Kewaunee Nuclear Power Plant
Operated by Nuclear Management Company, LLC

NRC-05-081
10 CFR 50.55a

Inservice Inspection Third 10-Year Interval June 16, 1994 - June 16, 2004 Limitation
To Examination Relief Requests of the Kewaunee Nuclear Power Plant

**INSERVICE INSPECTION THIRD 10-YEAR INTERVAL
JUNE 16, 1994 - JUNE 16, 2004 LIMITATION TO EXAMINATION RELIEF
REQUESTS OF THE KEWAUNEE NUCLEAR POWER PLANT**

PR-W12

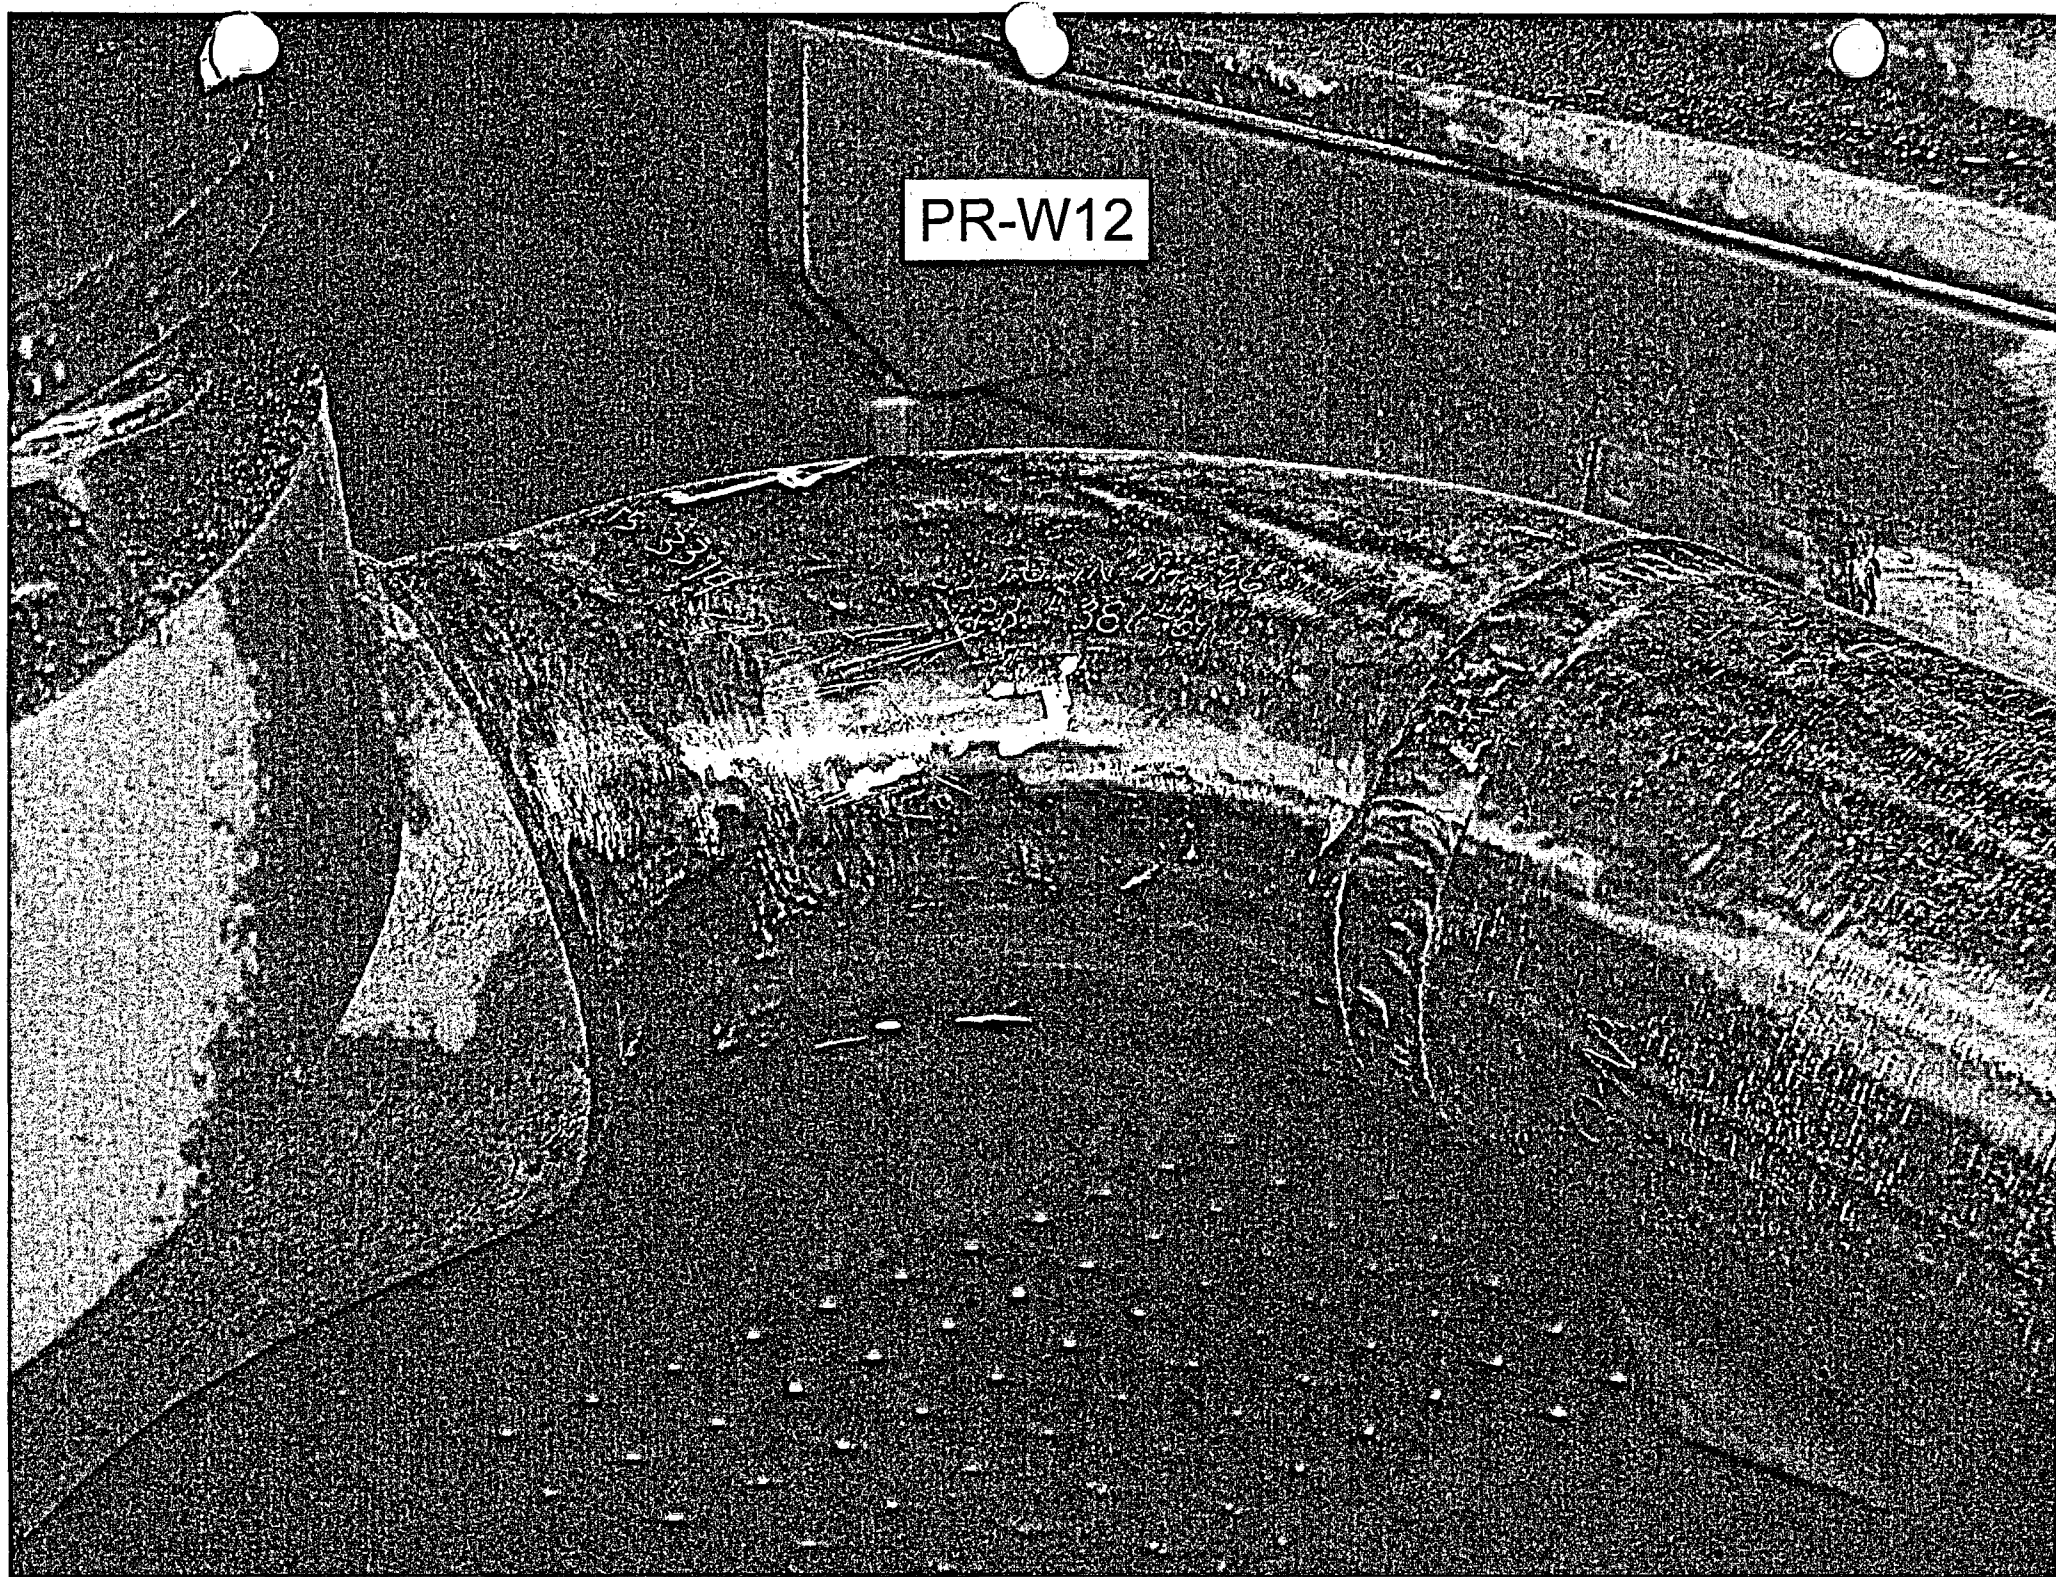
- 1. ASME Code Component Affected: 3" Pressurizer Relief Circumferential Weld PR-W12**
- 2. Applicable Code Edition and Addenda: 1989, No Addenda**
- 3. Applicable Code Requirement: Table IWB-2500-1; Examination Category B-J; Item No. B9.21**
- 4. Impracticality of Compliance: 74.0% of the 3" Pressurizer Relief Circumferential Weld PR-W12 was inaccessible due to a Whip Restraint RRRC39 thus restricting Surface Liquid Penetrant Examination.**
- 5. Burden Caused by Compliance: To provide for access to the 74.0% of the 3" Pressurizer Relief Circumferential Weld PR-W12 would require removal of the Whip Restraint RRRC39.**

Figure 1
Tan/Star Coverage Illustration
of the Safety Injection Nozzle
Protrusion Limitation

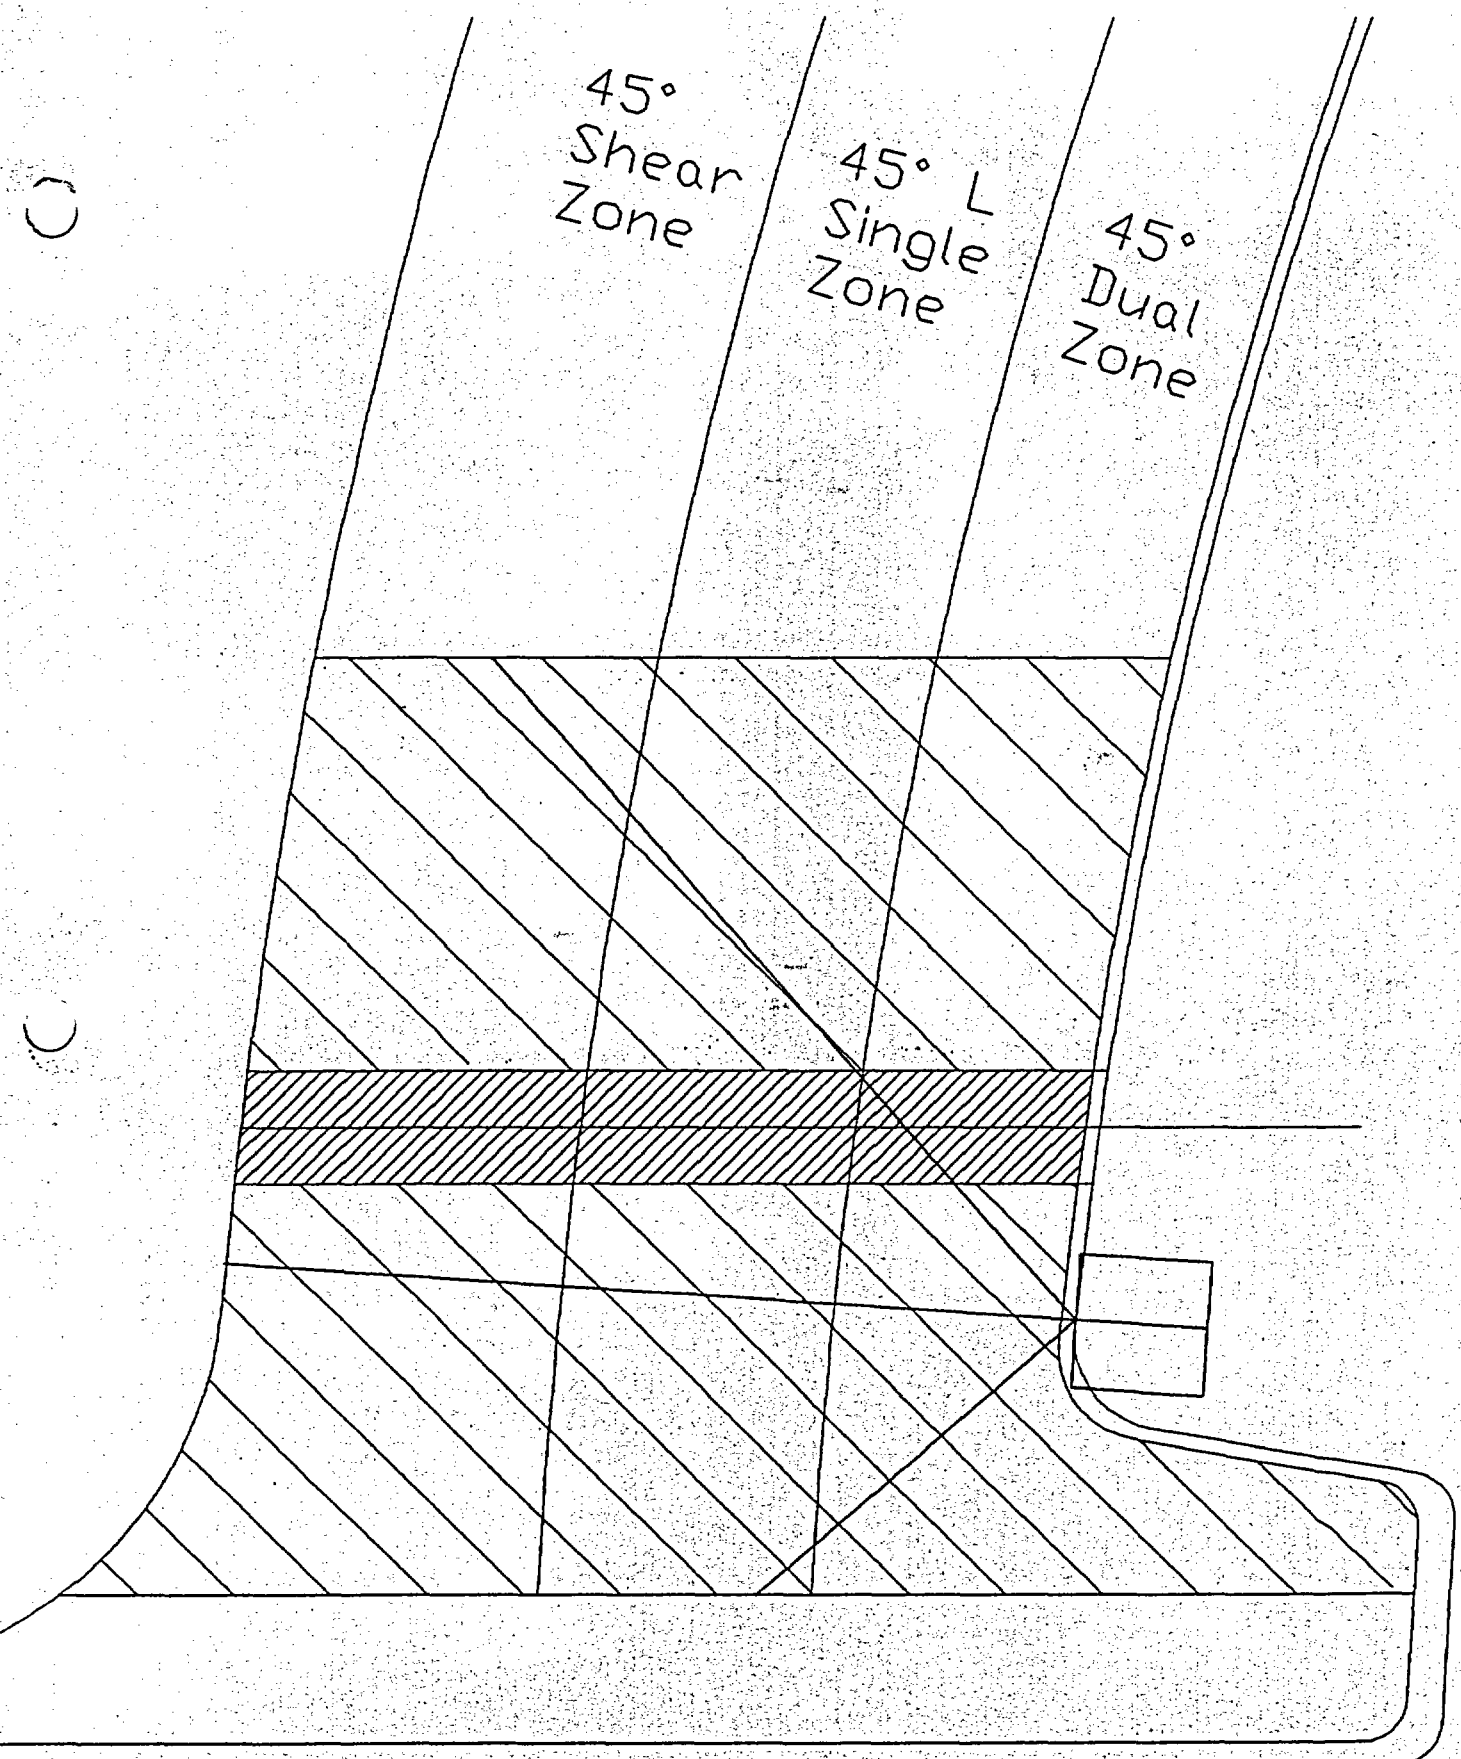
Comments: See figure 1 for limitations
